PREVOST

WARRANTY BULLETIN

WB12-35

DATE : NOVEMBER 2012	SECTION :	22 - HVAC
EXPIRATION:	NOVEMBER 2014	
SUBJECT :	PRE-HEAT EXHAUST TUBE CLEARANCE

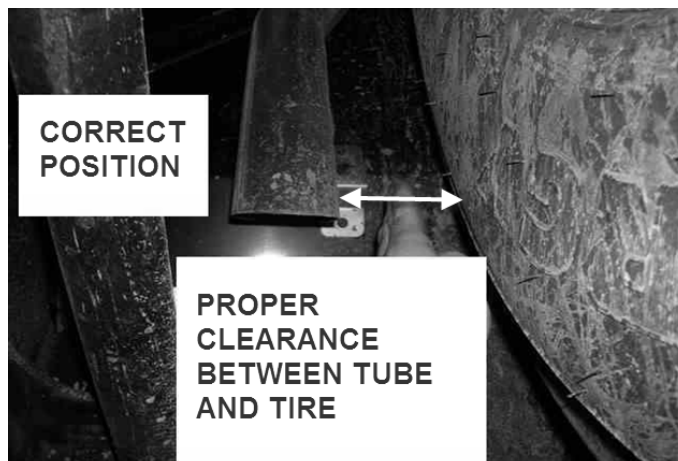
1. Remove the street side rear fender

2. Inspect the clearance between the Pre-heater exhaust tube and the tag axle tire.

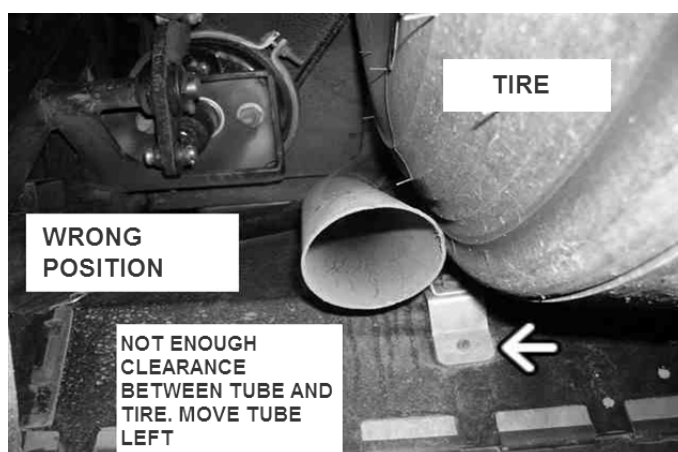
3. This is the correct position. Distance between tube and tire should be approximately 2 in.

If the tube shows this position, end the procedure.

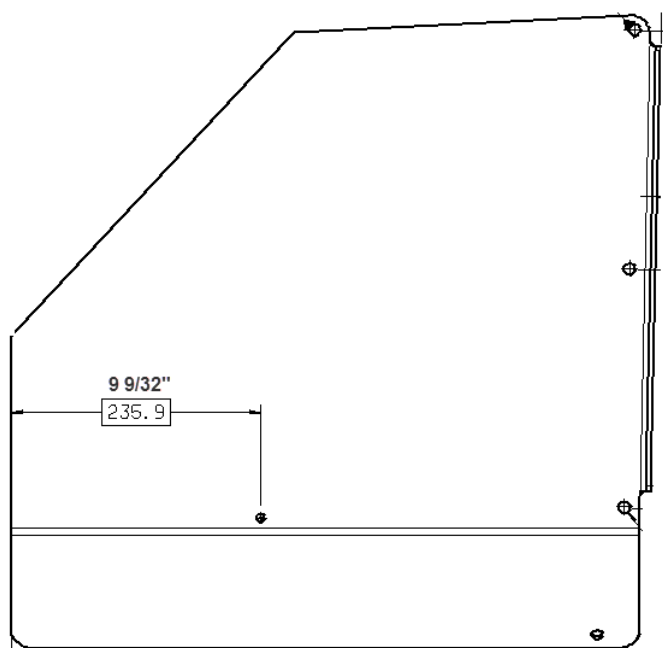
7. To help position the mounting bracket, there is a mark that indicates the proper mounting hole position on the plastic panel.

8. Secure at new position. Re-use mounting hardware.

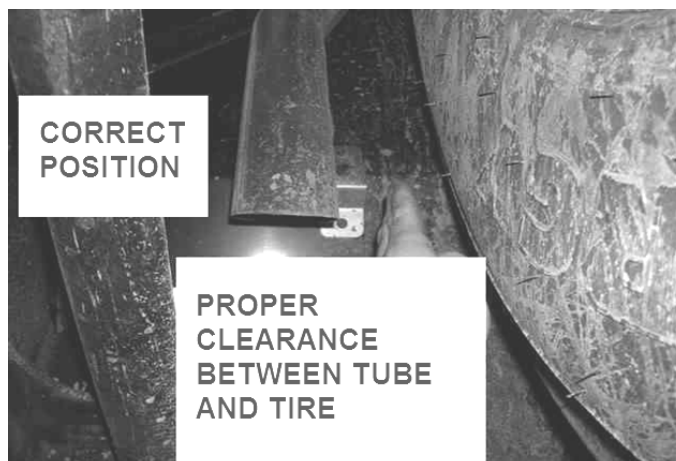
9. The final position should look like this.
